## ***Interactive comment on “A 2-D process-based model for suspended sediment dynamics: a first step towards ecological modeling” by F. M. Achete et al.***

**F. M. Achete et al.**

Received and published: 3 March 2015

Fig. 2.

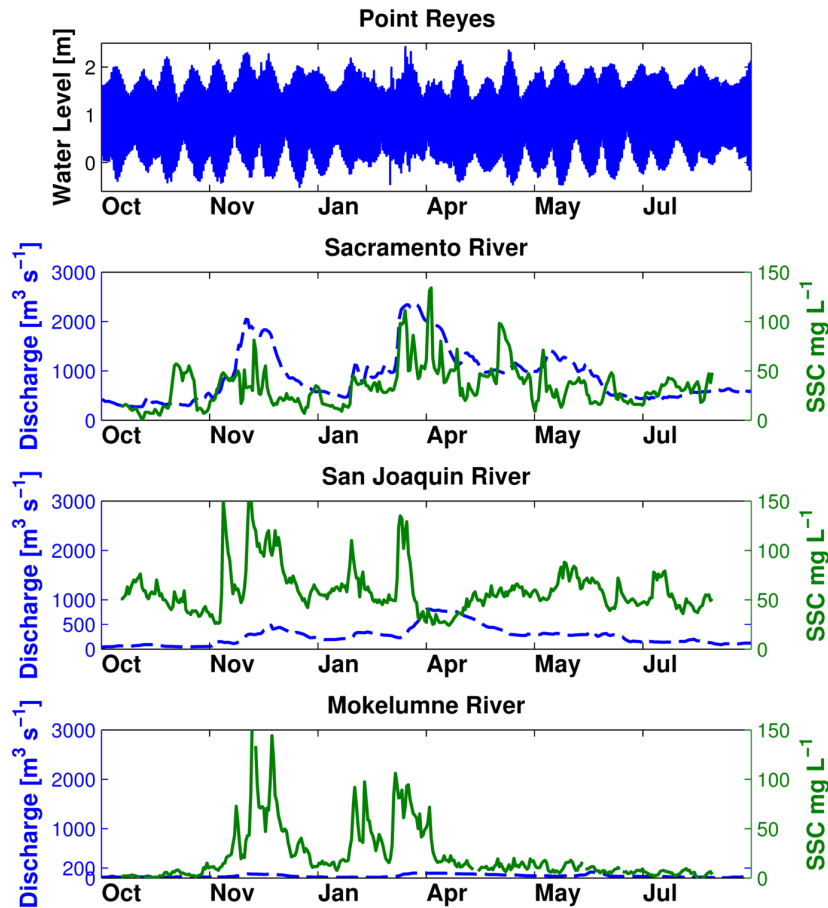
RC-Fig. 2 The labels and the location points of the calibration stations are too small. Please increase the font size.

AC-Figure updated.

Fig. 3.

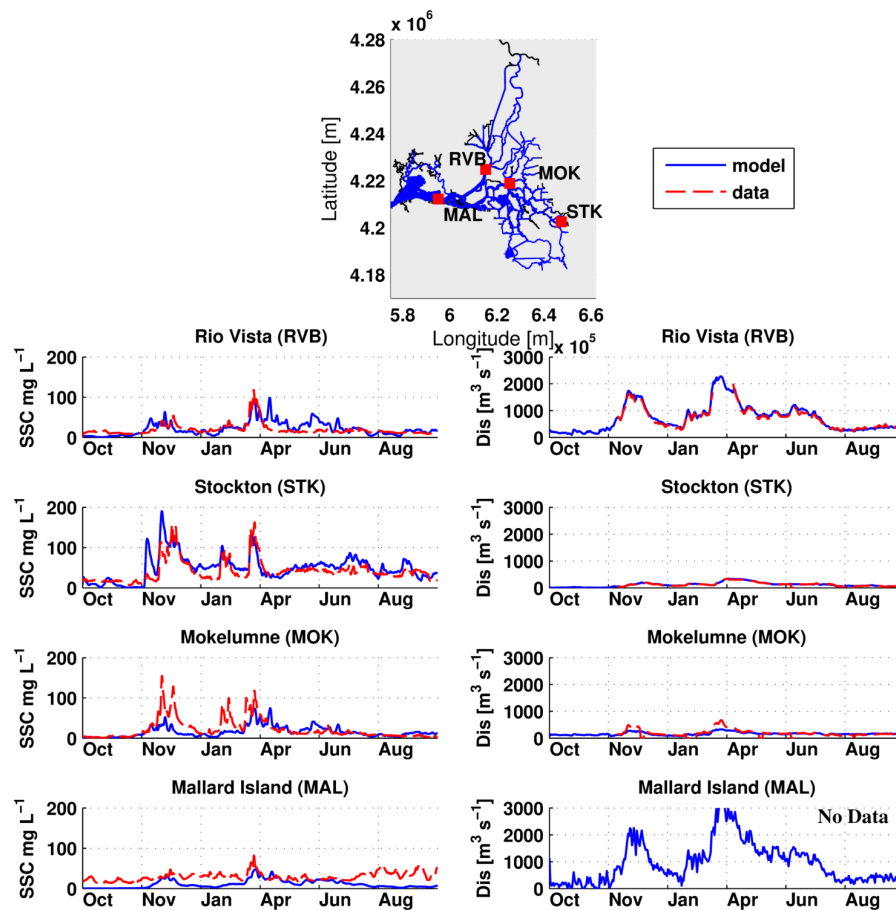
RC-Fig. 3: It is hardly visible that the blue line is dashed. The authors may increase the dash spacing or simply plot a blue line.

AC-Figure updated.
